**Addendum No. 3**

**Final Environmental Impact Report  
for Metro Gold Line Foothill Extension - Azusa  
to Montclair (SCH 2010121069)**

**Evaluating Minor Design Changes of the Project  
Azusa to Montclair**

Metro Gold Line Foothill Extension Construction Authority  
March 2016

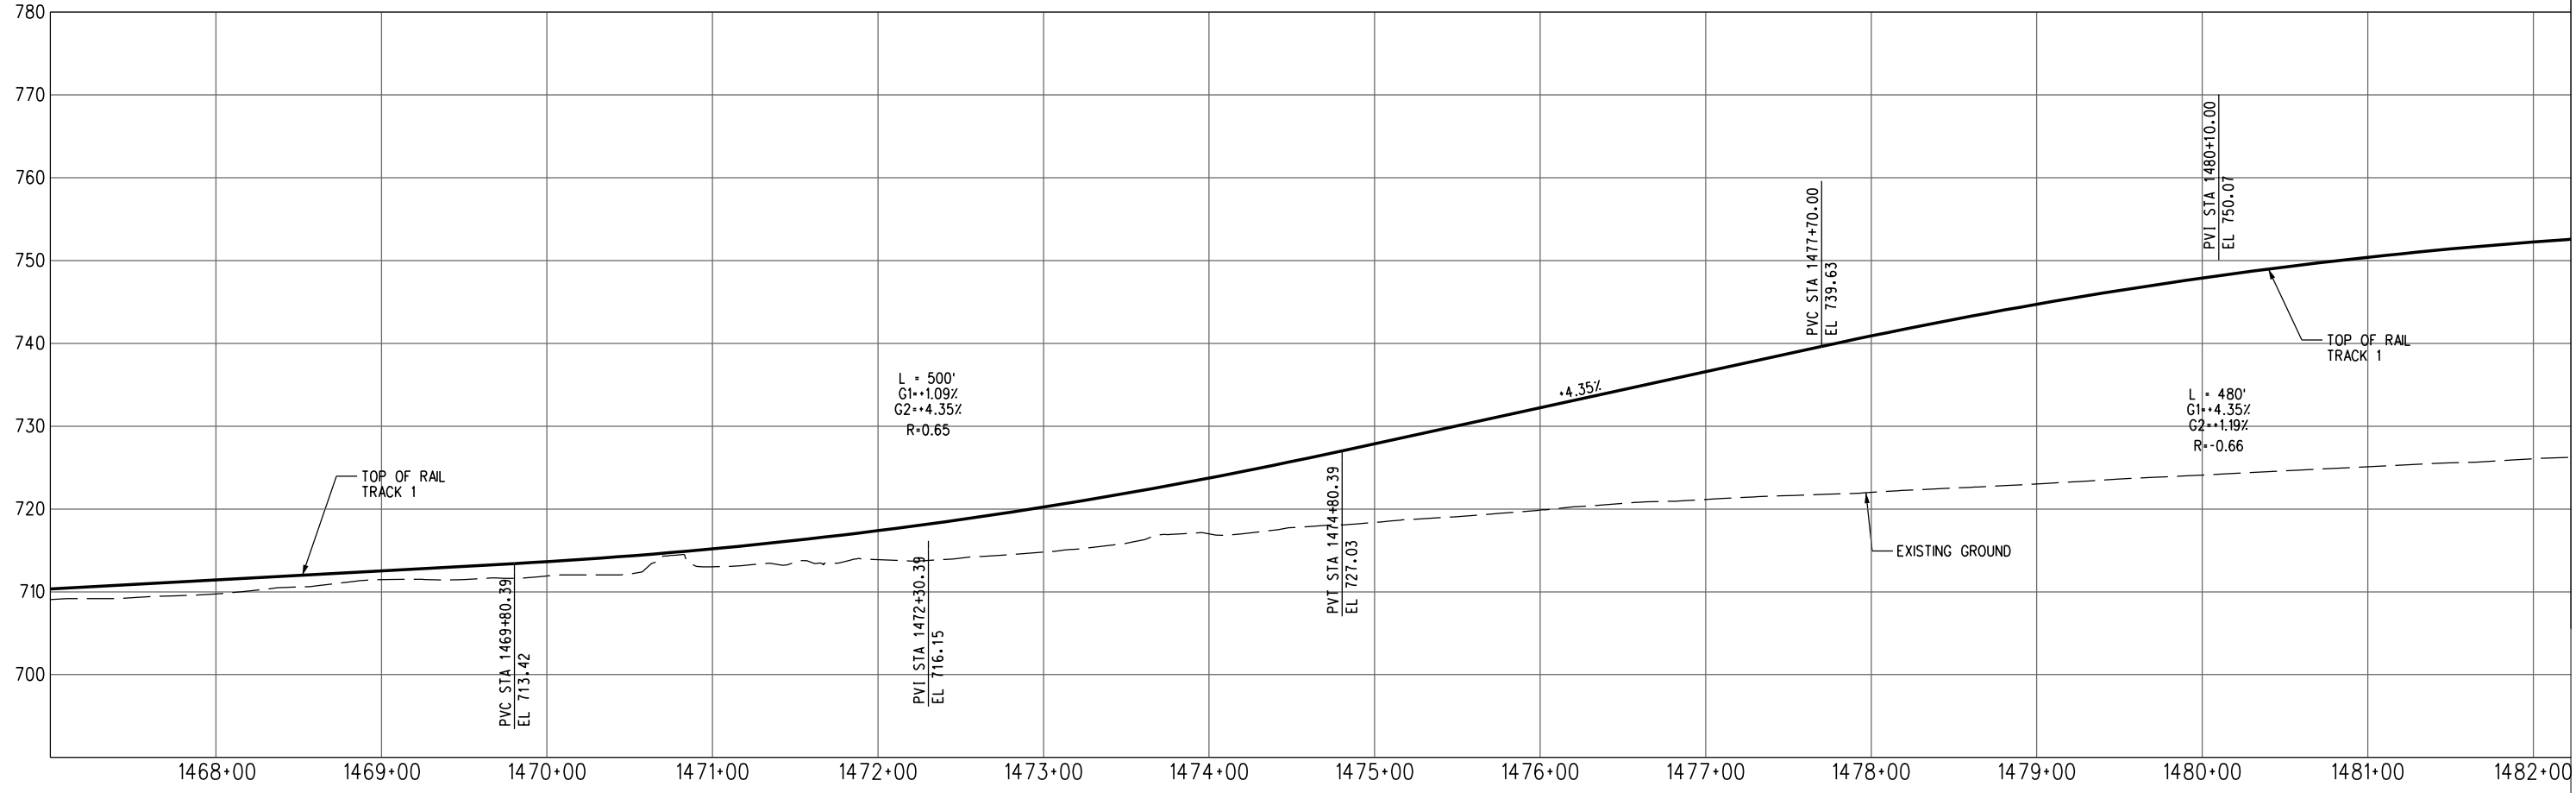
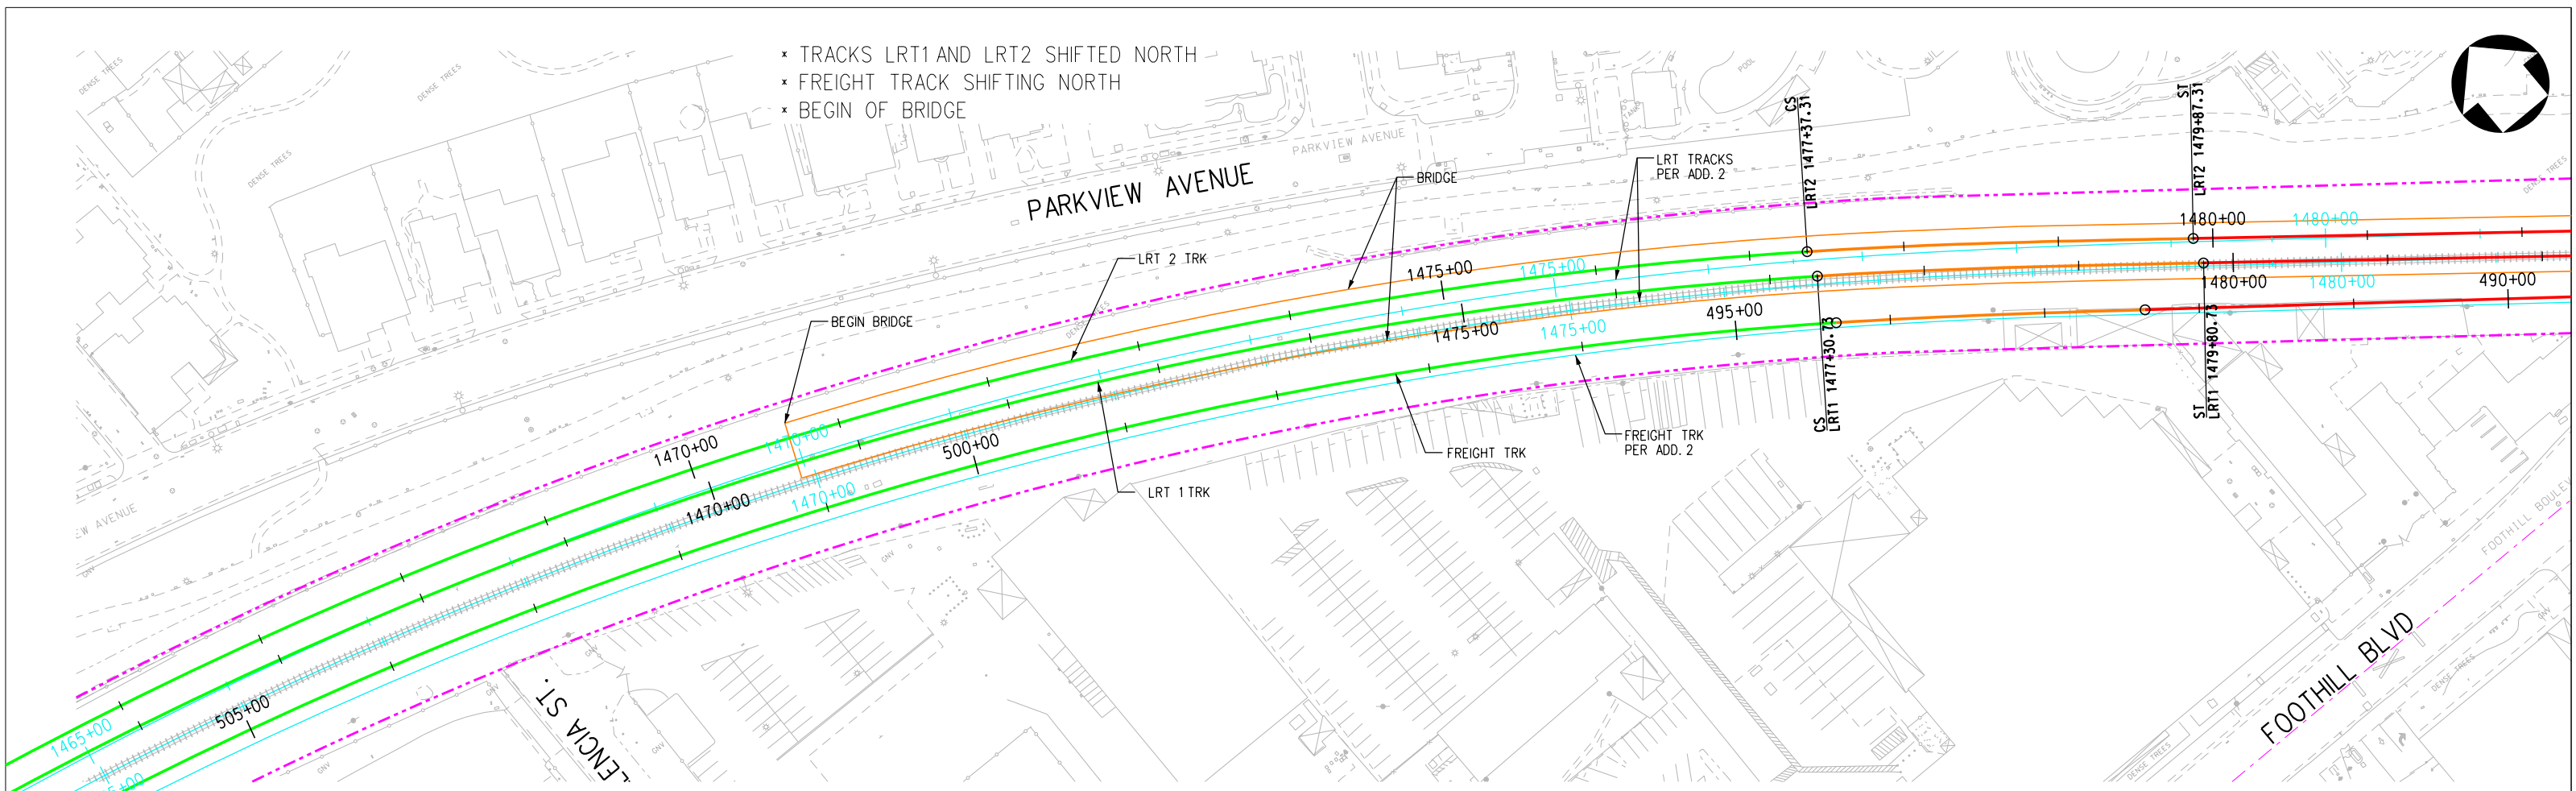
- ✕ TRACKS LRT1 AND LRT2 SHIFTED NORTH
- ✕ FREIGHT TRACK SHIFTING NORTH
- ✕ BEGIN OF BRIDGE
